REVIEW AND REFINEMENT OF ATC 3-06 TENTATIVE SEISMIC PROVISIONS

REPORT OF TECHNICAL COMMITTEE #4: CONCRETE

October 1980

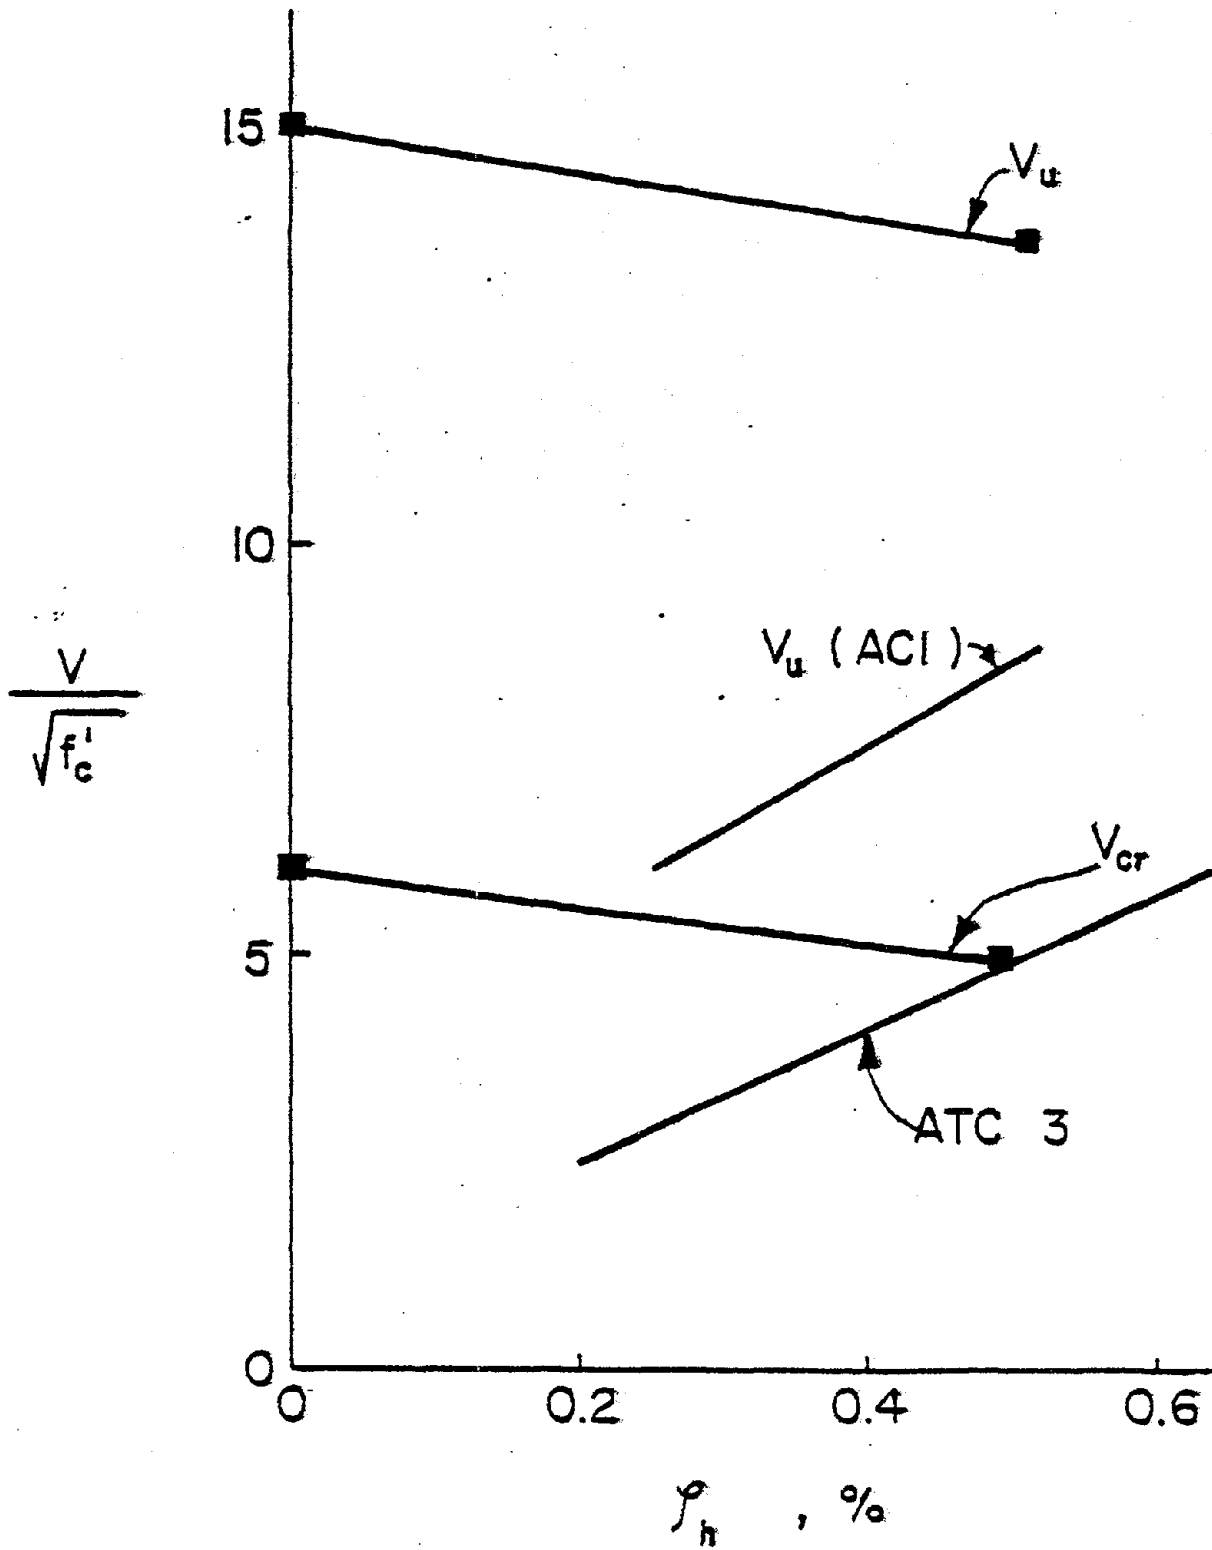
One of the most restrictive suggestions in Chapter 11 is Equation 11-5. The enclosed graph shows the proposed ATC-3 design requirement compared with results of tests on short walls. On the ordinate, shear strength is plotted, and on the abscissa, the amount of horizontal reinforcement. The top line indicates measured strength, the line marked v_u (ACI) is strength permitted by ACI 318-77, the line marked v_{cr} is the observed cracking strength and the bottom line is the strength proposed by ATC-3. As can be seen, at ultimate load the walls would have a load factor of 1.5 or more against cracking. The load factor on strength could be as high as 14.
